Figure 35 - Extract of the Discussion Drawing dated 9 September 2022 showing potential future conversion of the driveway

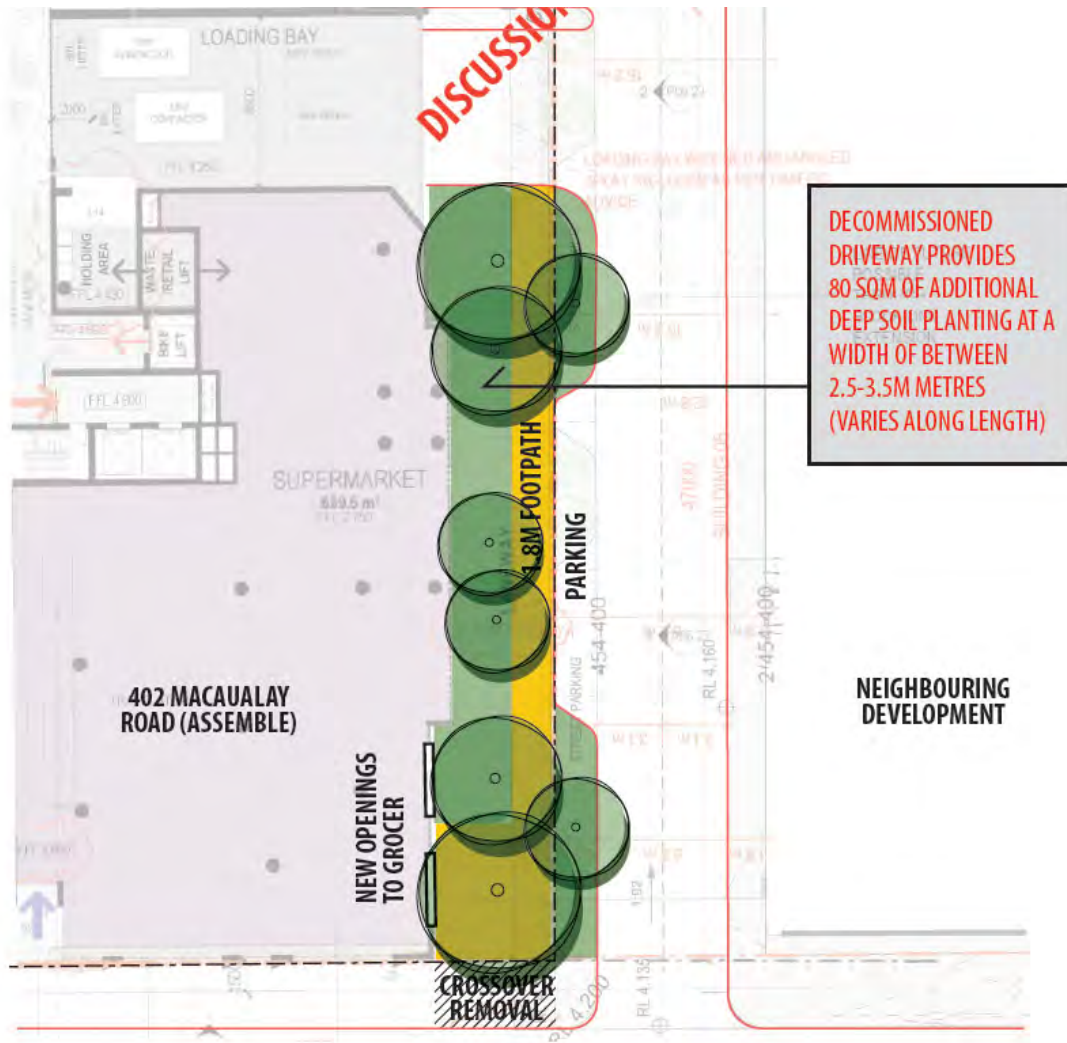
Council Officers raised concerns in relation to the potential location of the driveway, and driveway crossover adjacent to a future road during the application process for this application. As a result of these discussions, the permit applicant submitted a without prejudice discussion drawing on 12 September 2022, showing how the driveway could be converted into landscaped open space should the road be constructed along the eastern boundary. This would increase the extent of deep soil planting from 650 to 730 m² (9.8%), improve pedestrian safety, connectivity through the site and the development's interface to Macaulay Road. An extract from that plan is reproduced at Figure 35.

The permit applicant indicated that they would accept a permit condition requiring any future permit holder to enter into a Section 173 Agreement for the land to be redeveloped in accordance with the discussion drawing, should the road on the adjacent property be constructed.

- a) Should a new carriageway be constructed at 352 Macaulay Road, Kensington which would allow for direct access to the loading bay and basement ramp on the subject site; the land along the eastern boundary of the site must be redeveloped within two years of the road completion generally in accordance with the drawing titled 'Future Driveway Interface Condition' dated 12 September 2022. The required works include, but are not limited to:

- iv. Provision of a small plaza at the south-eastern corner of the site.
 - v. Provision of landscaped open space with canopy tree planting within remaining areas, replacing areas where the driveway has been removed to the satisfaction of the Melbourne City Council.

Figure 39 - Overlooking Section 2 depicting proposed overlooking mitigation measures. From Drawing TP07.10

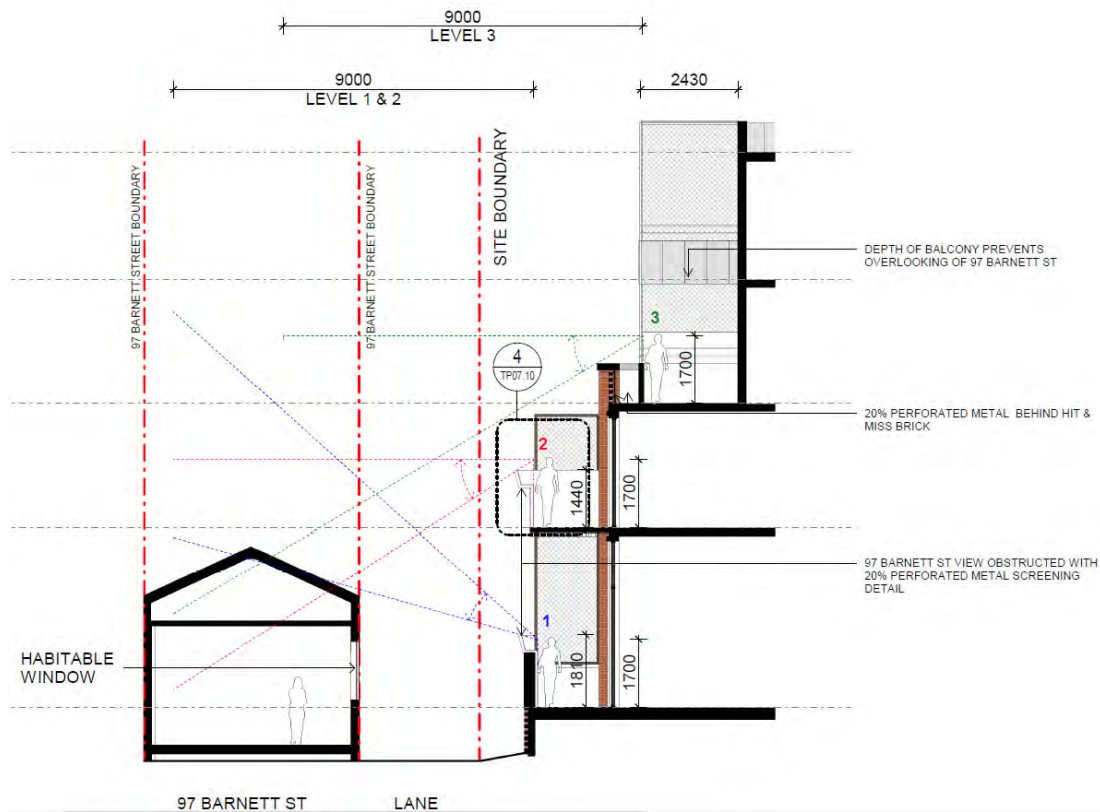
Building 1 is, however, built closer to the dwelling at 97 Barnett Street and therefore requires a considered assessment of potential overlooking impacts.

- h) All awnings across the road reserve amended to maintain a three metre clearance above the footpath.
- i) All instances of metal overlooking screens on Building 1 revised to a more suitable material such as metal fins or timber battens to mitigate overlooking in accordance with Standard B22 at Clause 55.04-6.

Figure 40 - Level 1 Plan extract showing apartments in Building 1 where windows to bedrooms face either a narrow light court or corridor

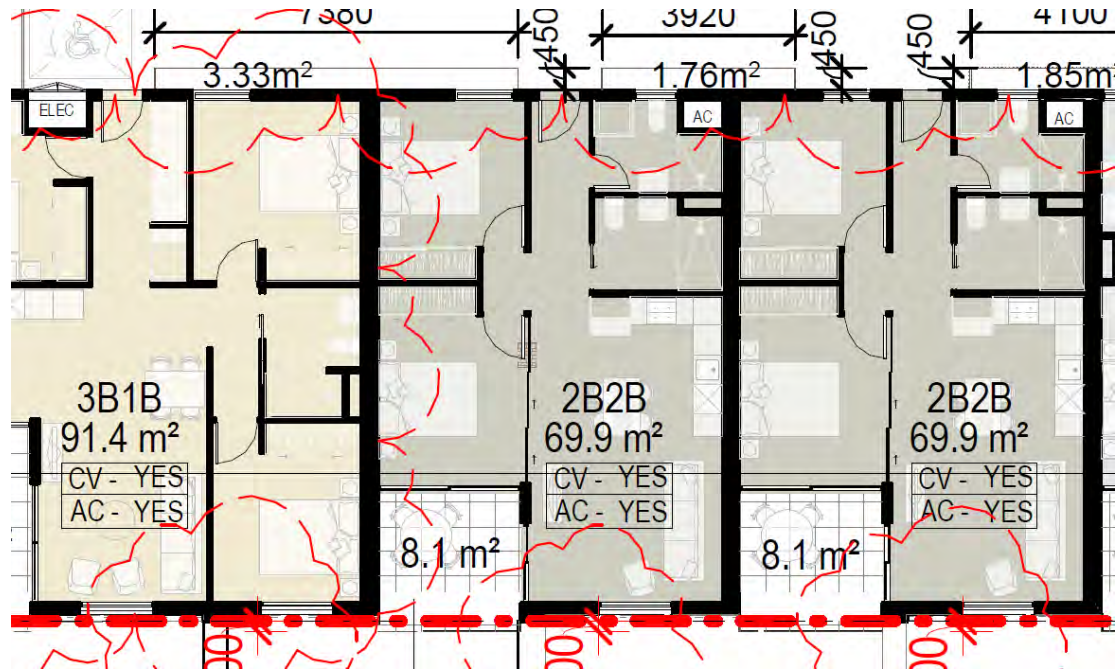
As noted in the BESS Daylight Assessment that is appended to the Sustainability Management Plan prepared by Frater, dated 25 March 2022, the 12 bedrooms facing a lightcourt receive an 'auto-pass' based on lightcourt dimensions.

With respect to the remaining three bedrooms which directly face the corridor rather than a lightcourt, these do not meet the minimum daylight criteria. That represents a 'pass rate' of approximately 93 per cent, which is in excess of the 80% BESS minimum and is considered acceptable for a development of this type. This has also been accepted as a reasonable outcome by Council's ESD Officer.
